Upper Trinity River Central City Fort Worth, Texas

Final Supplement No. 1
to the Final
Environmental Impact
Statement

Prepared by:
U.S. Army Corps of Engineers
Fort Worth District

March 2008

SHEET IDENTIFICATION
CG-06

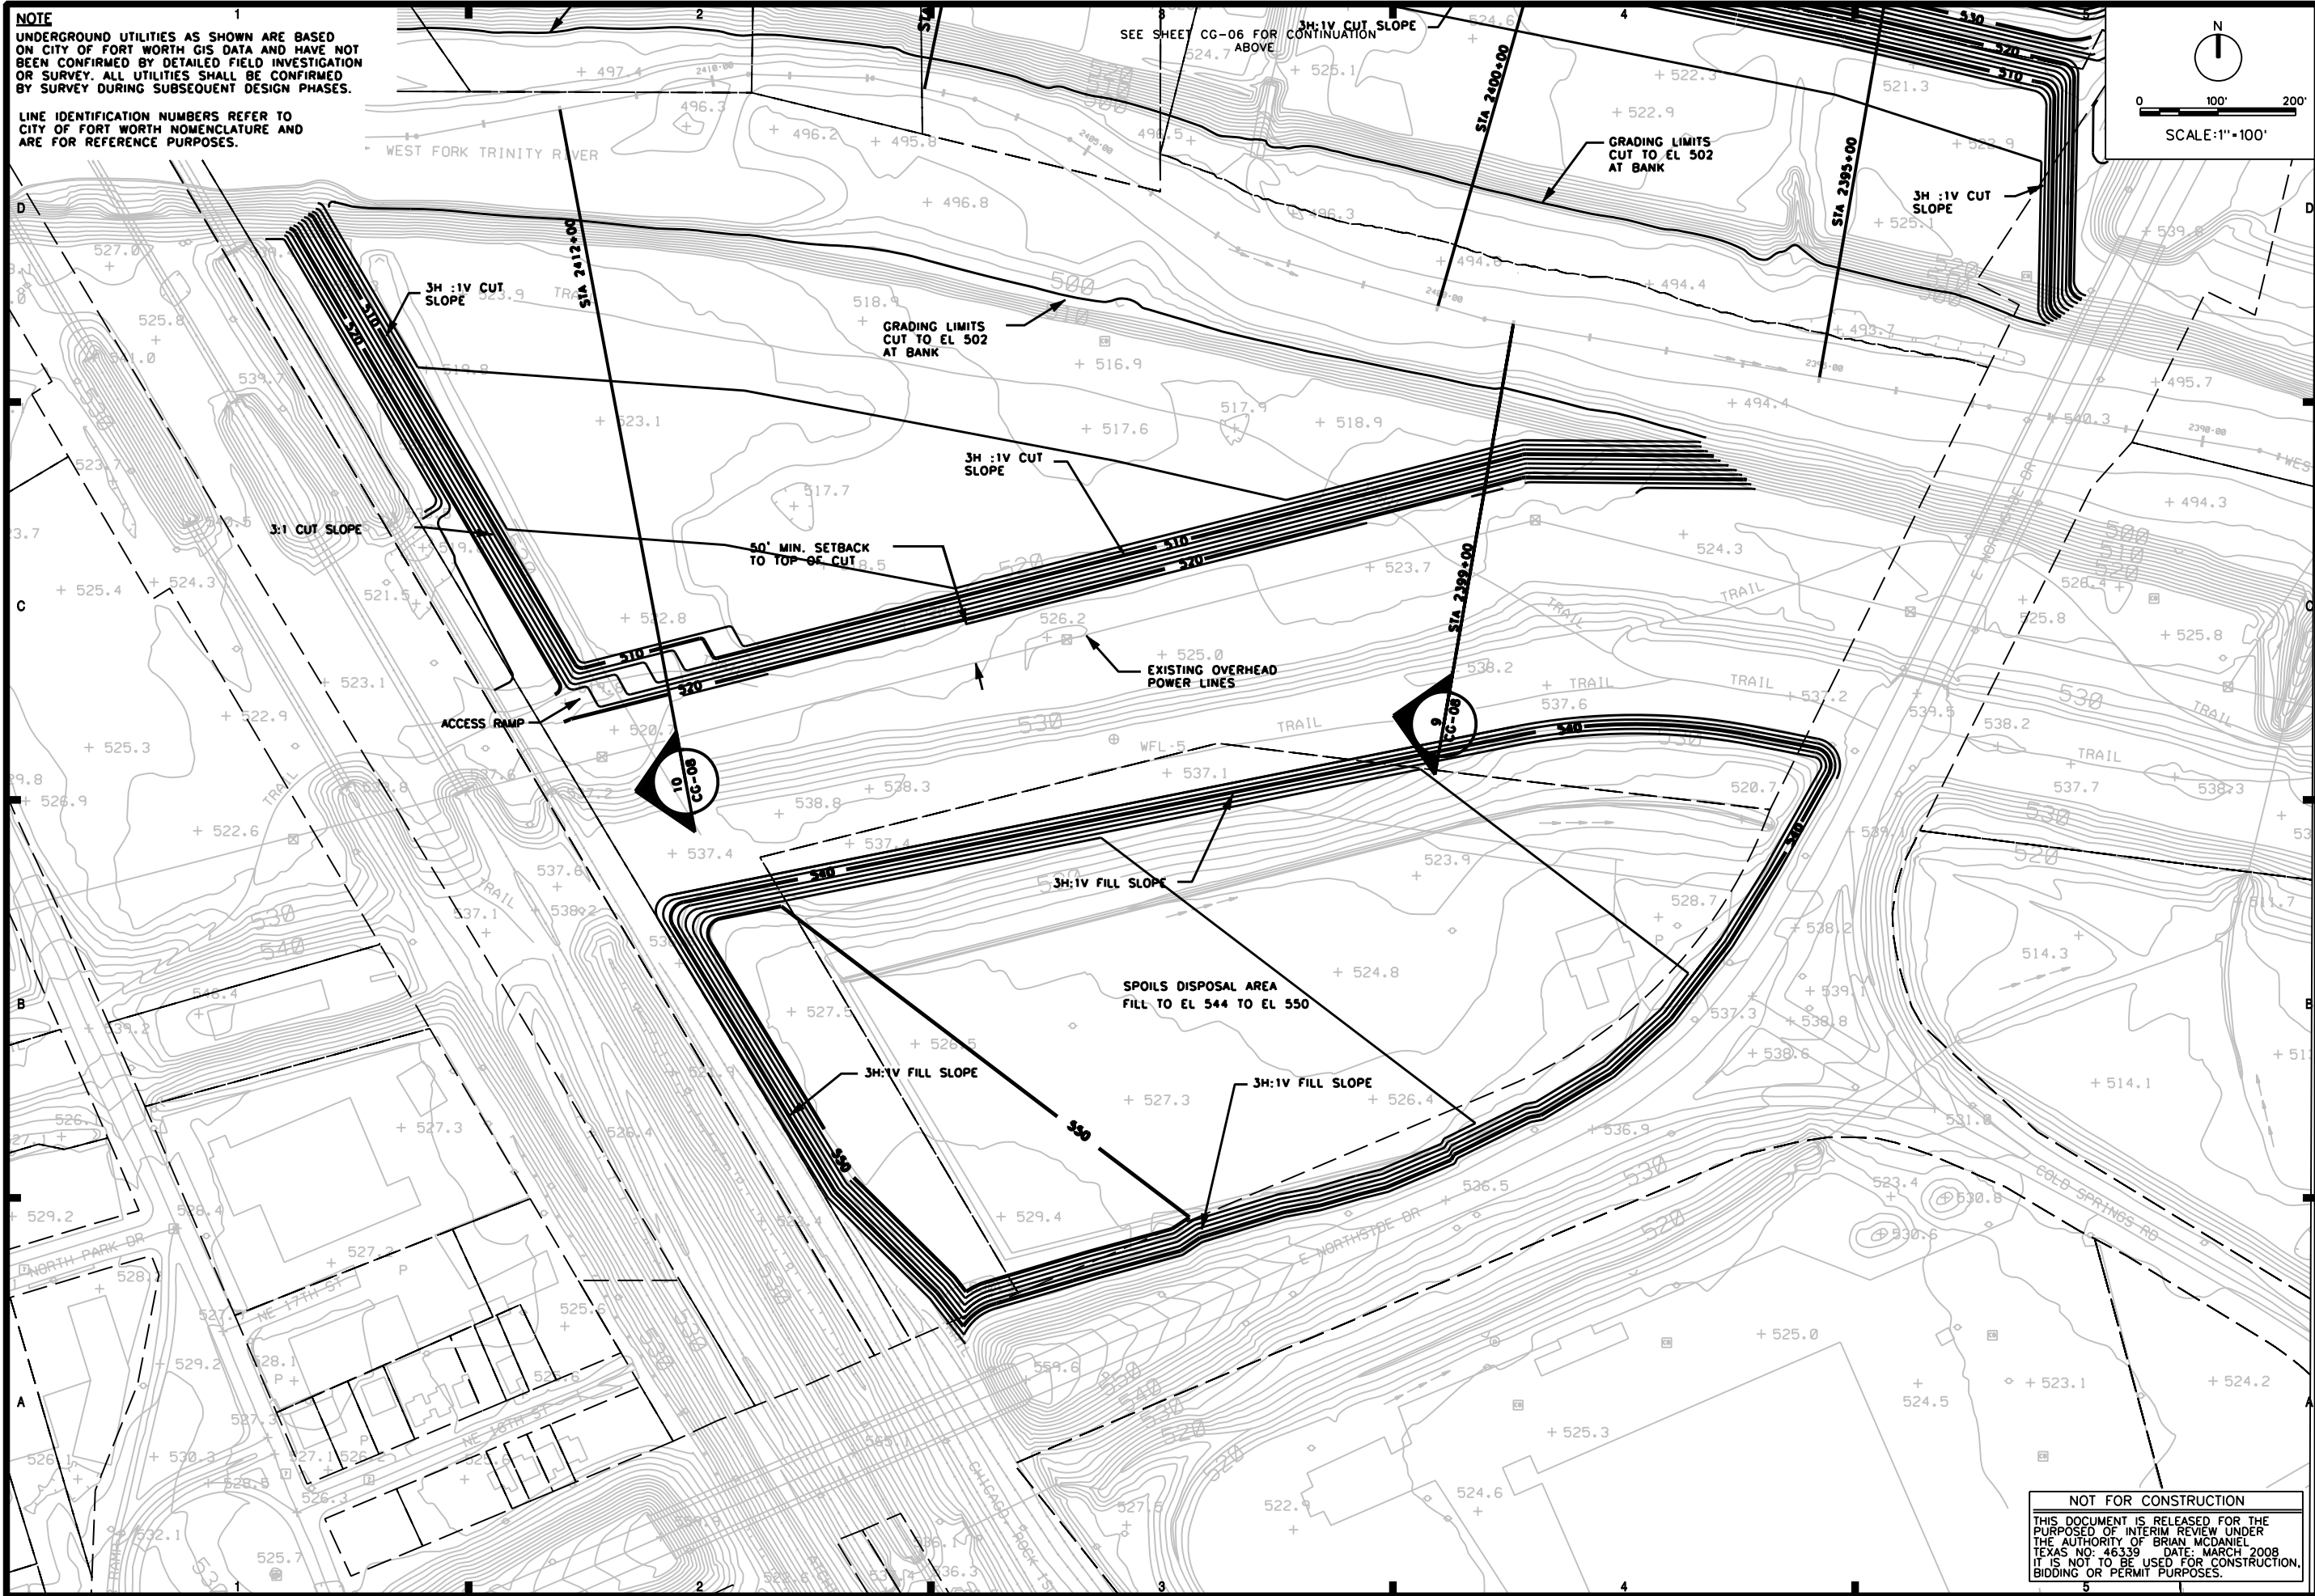
Site 5a: Appendix E, page 6, states, "Negative impacts to Lebow Creek would be totally eliminated..." Figure CG-06 in Appendix C, Volume II indicates that the lower east bank of Lebow Creek would be excavated as part of the proposed valley storage Site 5a. The DSEIS does not address this impact. We recommend that excavation of Lebow Creek be avoided and the boundary of the proposed valley storage Site 5a be located further east as to not cause adverse impacts to the creek.
